Palisades Nuclear Plant
Docket 50-255
License No. DPR-20

Response to Request for Additional Information Regarding License Amendment
Request: Removal of TSP from Palisades Containment

ENCLOSURE 1
RESPONSE TO RAI ON TSP AMENDMENT
PALISADES NUCLEAR PLANT

EA-EC976-10	Revision: 0
	Date: 10/24/2006	
	Total Number of Pages: 24	
Title: NaOH Addition Mission Dose		
Approval: See signature page

Attachment 1: NaOH Mission Path (2 pages)

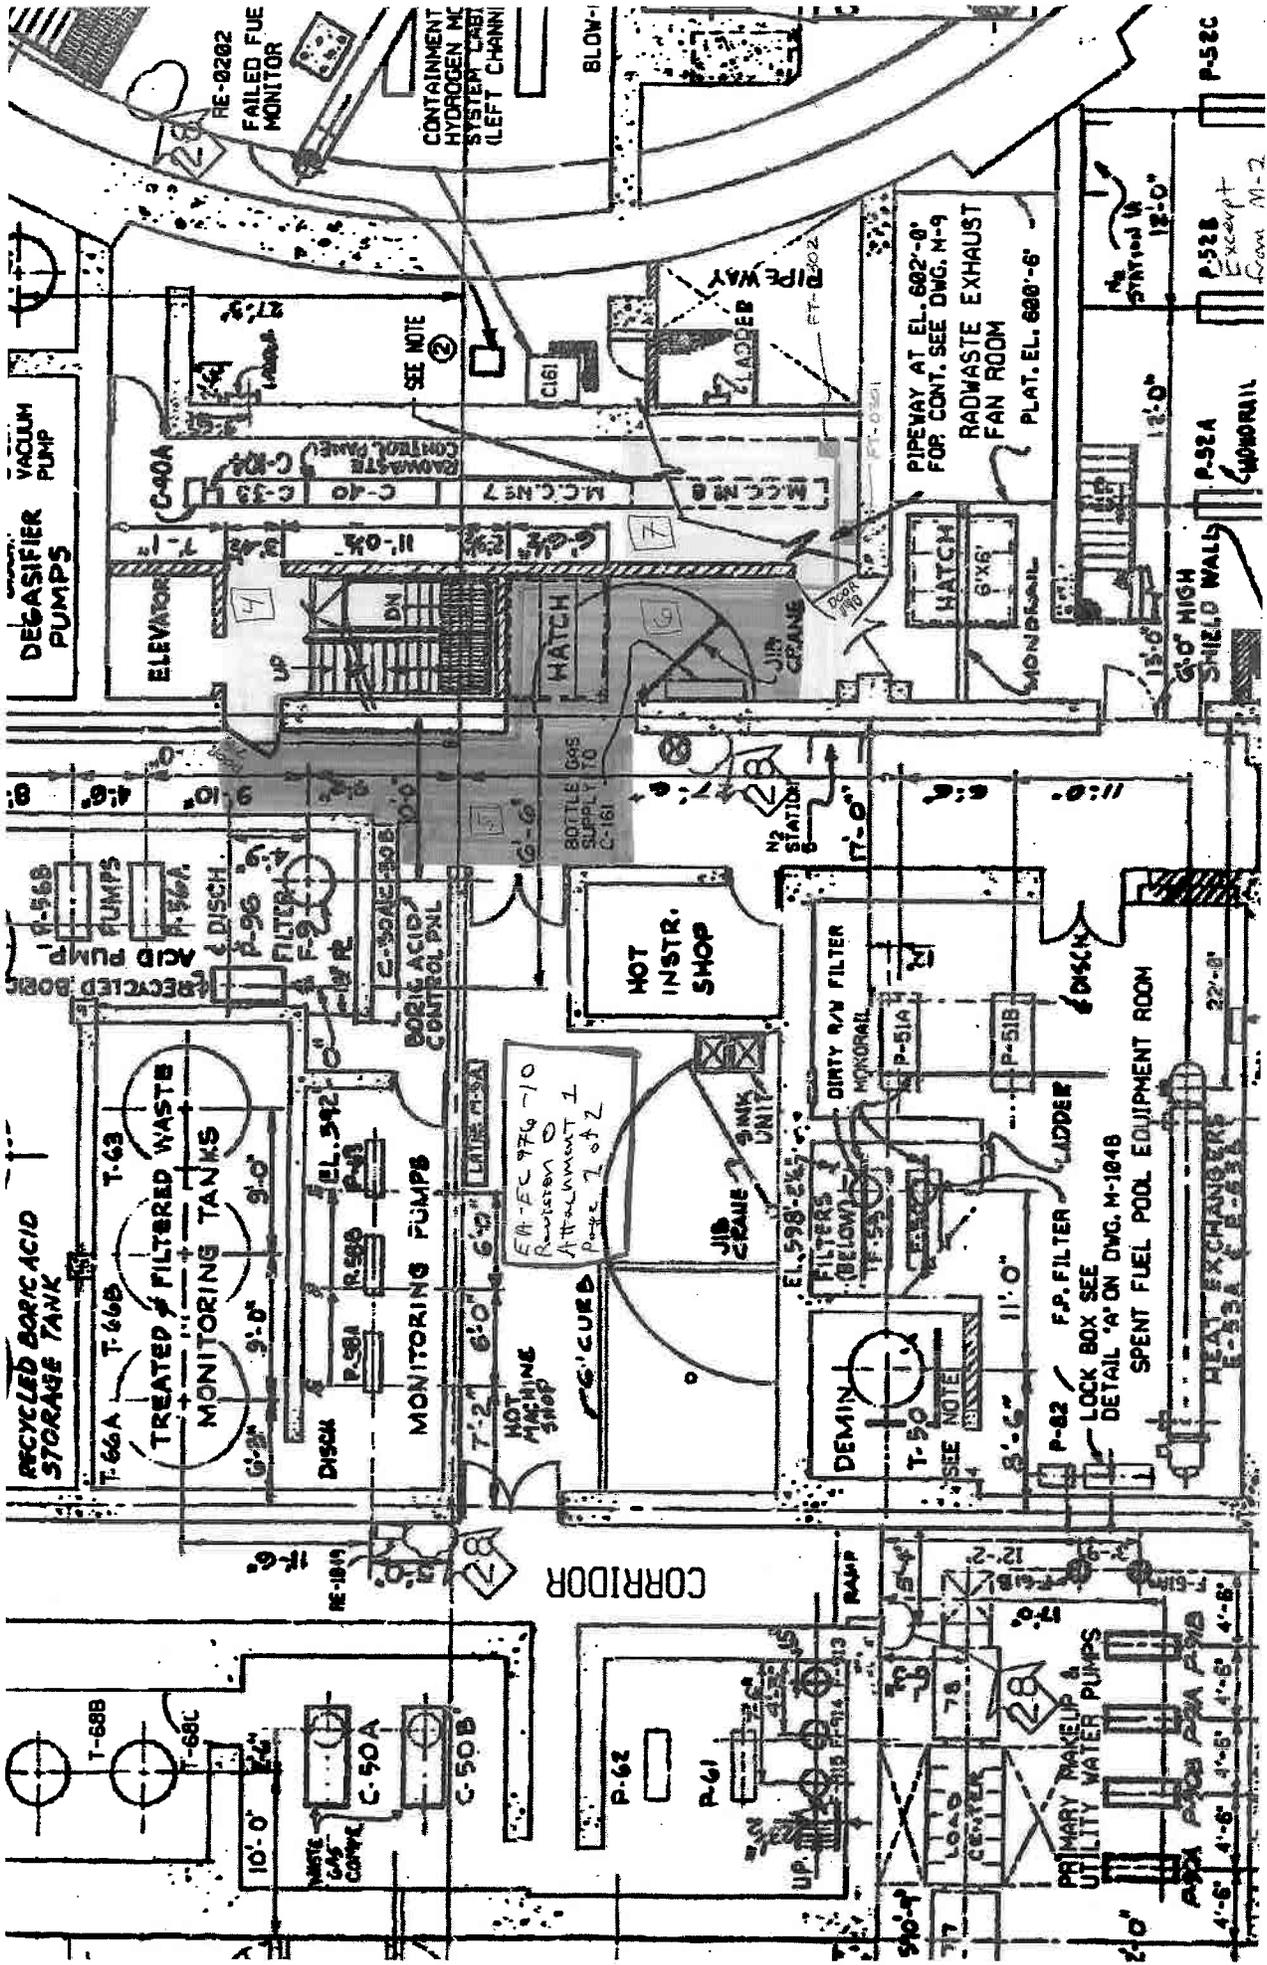
- a. *Provide plant layout drawings showing the path that an operator(s) would take to access the NaOH injection system, make the required hookups, initiate the injection of NaOH into the containment spray headers, and leave the area.*

1.
 - a. A time motion analysis of the NaOH addition mission has been performed. The analysis, EA-EC976-01, "NaOH Addition Mission Dose," is provided as Enclosure 2. Plant layout drawings are provided in Attachment 1 of Enclosure 2. The paths are indicated on mark-ups of plant drawings M-2 and M-3.
 - b. The mission dose to the operator has been determined in Enclosure 2. The analysis concludes that a reasonable and conservative estimate of the maximum radiological dose received by a single individual performing the NaOH addition mission is less than the 5 rem TEDE limit. Therefore, measures such as the use of additional shielding or the use of multiple

These areas are indicated in the marked-up plant drawings in Attachment 1 from Refs. [14] and [15]. Note that the location of the pre-staged equipment may not be exact within mission area 1 but that all pre-staged equipment will be located in mission area 1 or a lower dose area.
